h4 Doc  
RESPONSE TO FREEDOM OF INFORMATION ACT (FOIA) / PRIVACY ACT (PA) REQUEST

2000-0096

FACILITIES: Shearon Harris Nuclear Power Plant, Unit 1

SHEARON HARRIS NUCLEAR POWER PLANT  
DOCKET NO. 50-400/LICENSE NO. NPF-63  
RESPONSE TO NRC REQUEST FOR ADDITIONAL  
INFORMATION REGARDING THE ALTERNATIVE  
PLAN FOR SPENT FUEL POOLS C & D COOLING  
AND CLEANUP SYSTEM PIPING

Figure RA1 11

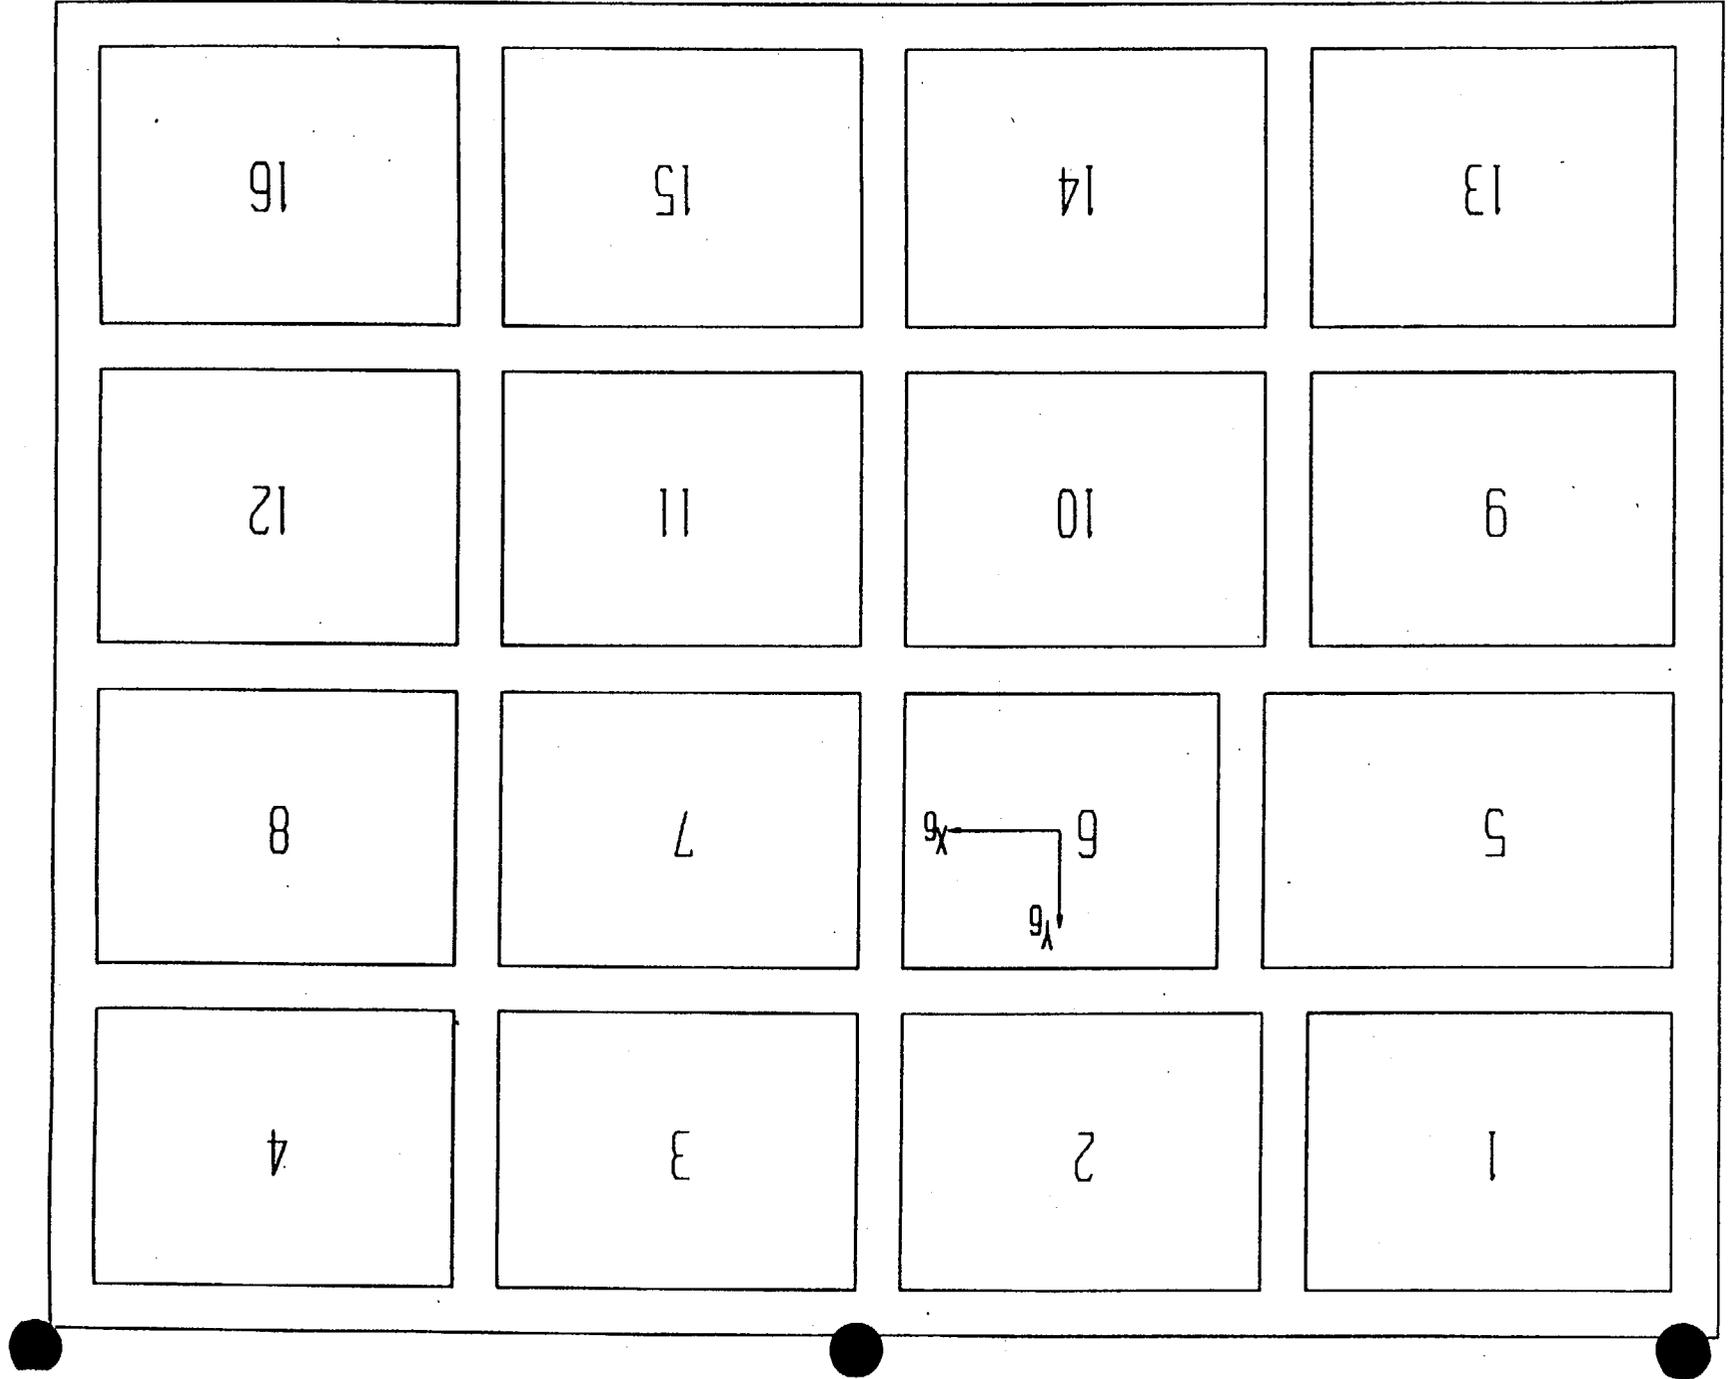
The problem to be investigated is shown in Figure RAI 1.1 (Enclosure 2), which shows an orthogonal array of sixteen rectangles which represent a unit depth of the sixteen spent fuel racks in the Shearon Harris Spent Fuel Pool. The rectangles are surrounded by narrow fluid filled channels whose width is much smaller than the characteristic length or width of any of the racks. The spent fuel pool walls are shown enclosing the entire array of racks.

As an example, refer to Figure RAI 1.1 (Enclosure 2), where an array of  $N$  ( $N = 16$ ) two-dimensional bodies (each with two degrees of freedom) is illustrated. The dynamic equilibrium equation for the  $i$ -th mass in the  $x$ -direction can be written as:
